Technical Service Information

GM 4L60/65/70E

INPUT CARRIER CHANGE

Figure 1

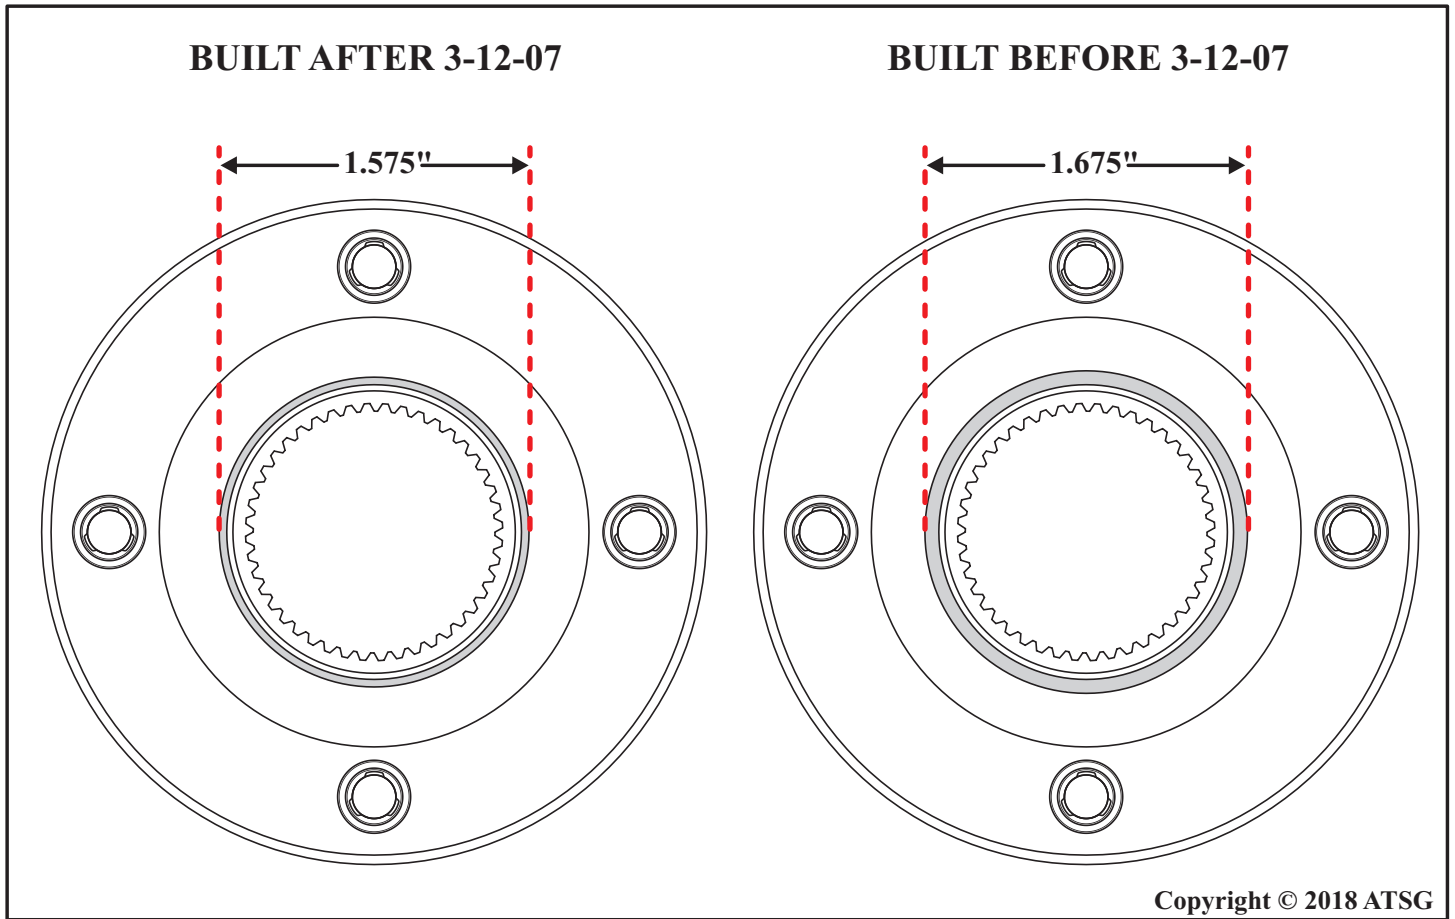
CHANGE: All 4L60E/65E/70E transmissions with a build date of 3012-07 (Julian Date 7071) have had changes made to the input carrier to reaction carrier shaft bearing. The input carrier and the reaction carrier shaft were modified to accommodate the bearing change.

The input carrier changed dimensionally as shown in figure 1. The bearing dimensional changes are shown in figure 2 while the reaction carrier shaft dimensional changes can be seen in figure 3.

Figure 2

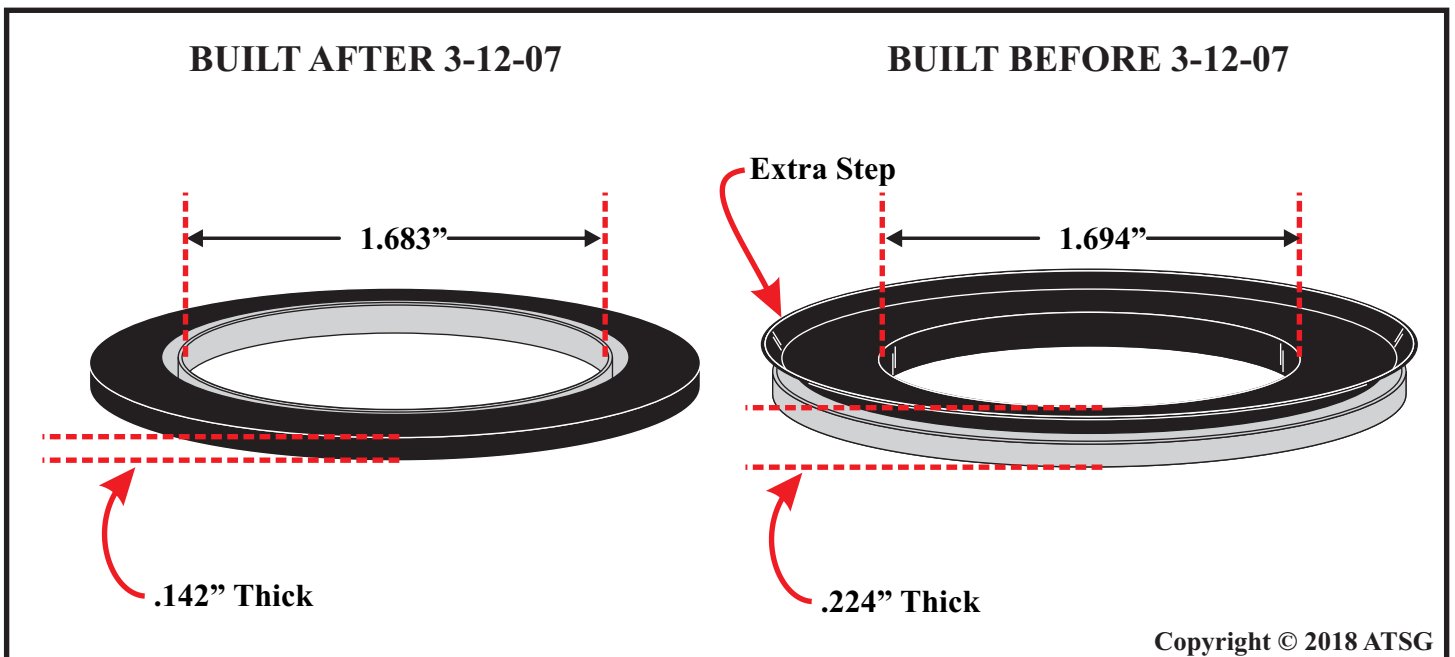
REASON: Increased bearing capacity for durability reasons.

Current Design Input Carrier To Reaction Carrier Shaft Bearing.....24236092
Current Design Input Carrier.....24241241
Current Design Reaction Carrier Shaft.....24241255
